# CITY OF ALBUQUERQUE

**RE: Applebees and 14k Retail Building  
Grading and Drainage Plan  
Engineer's Stamp Date 4-03-2015 (File: K09-D038)**

drawing number  
C2

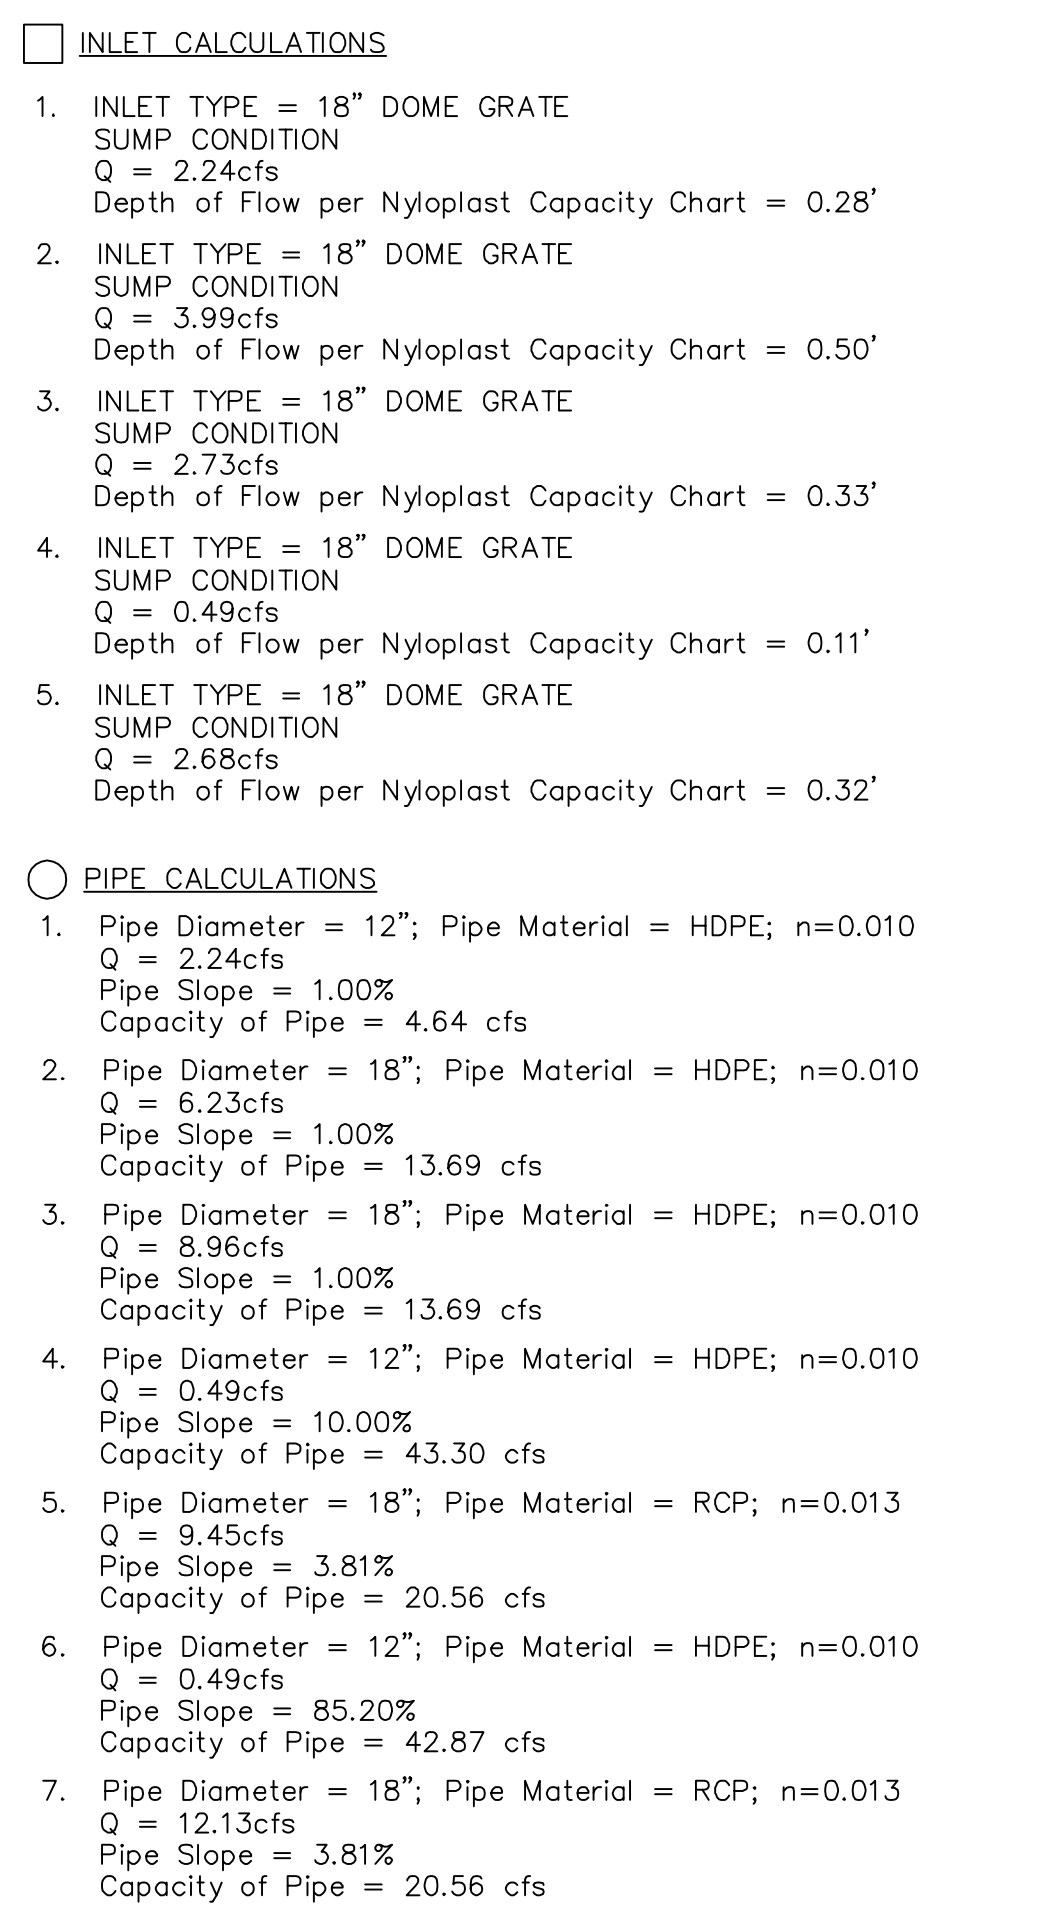
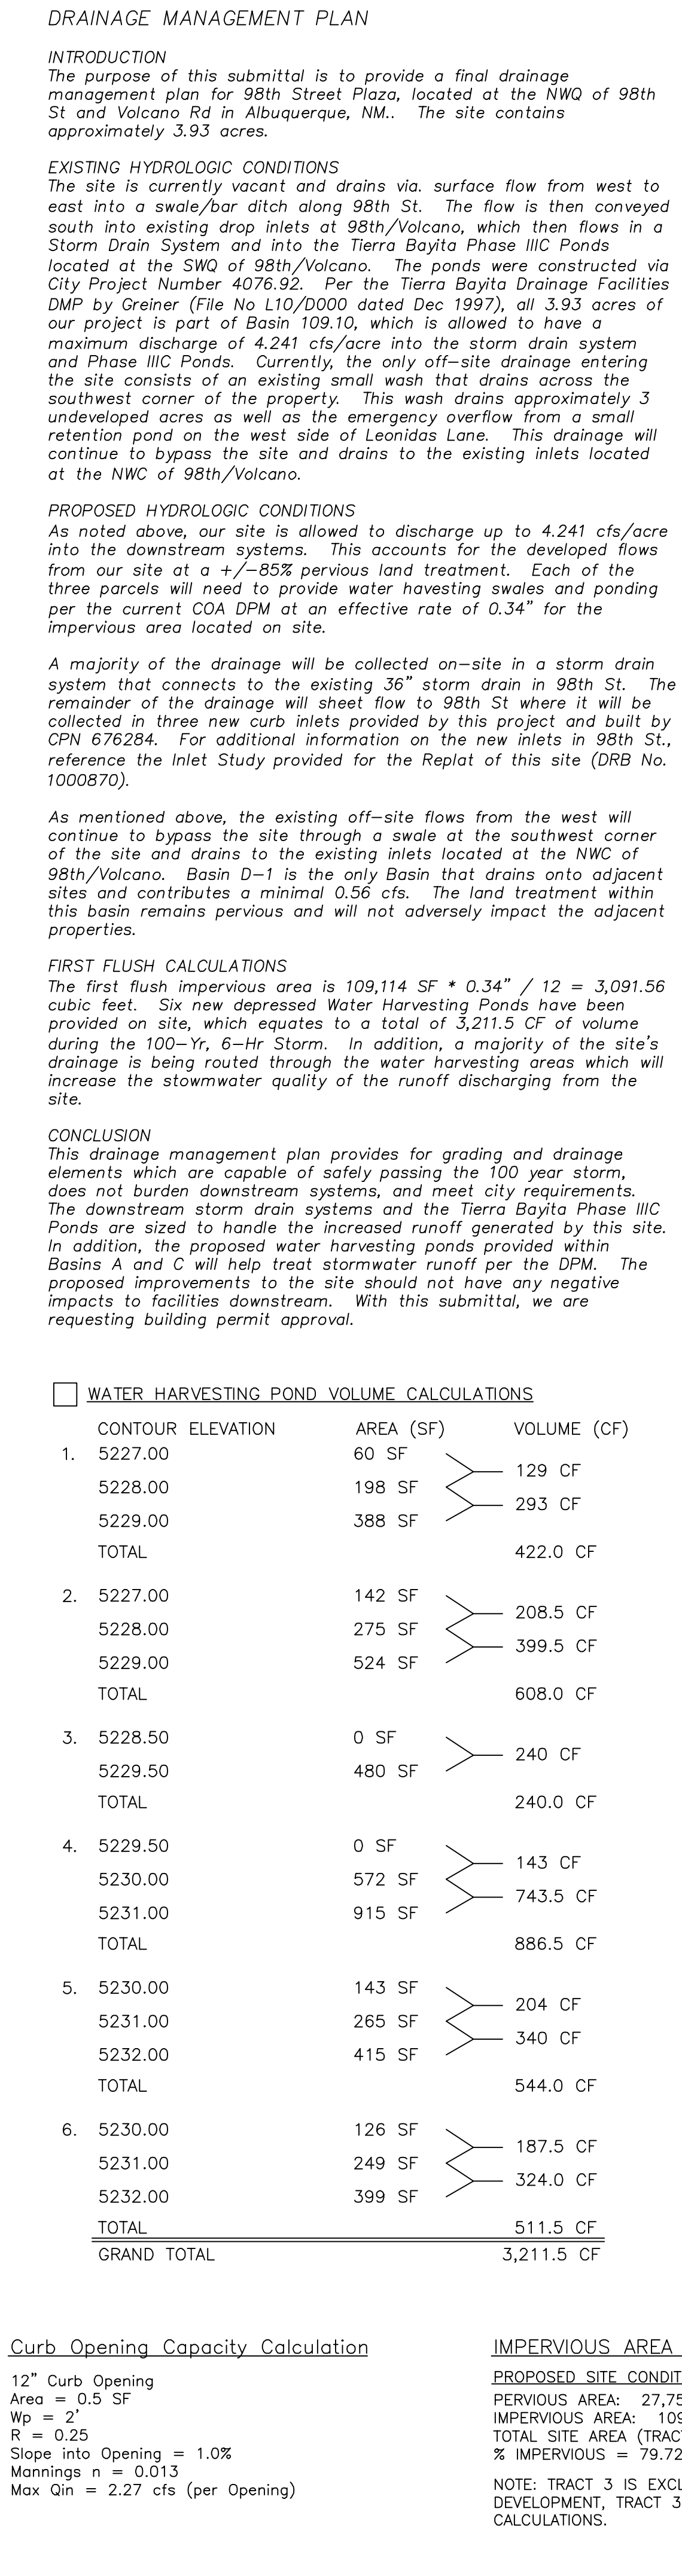
Based upon the information provided in your submittal received 4-03-15, the above referenced plan is approved for Building Permit. Please attach a copy of this approved plan in the construction sets when submitting for a building permit.

PO Box 1293 Prior to Certificate of Occupancy release, Engineer Certification per the DPM Checklist will be required. Additionally, it will be required to submit the construction work within COA right-of-way through the DRC Process.
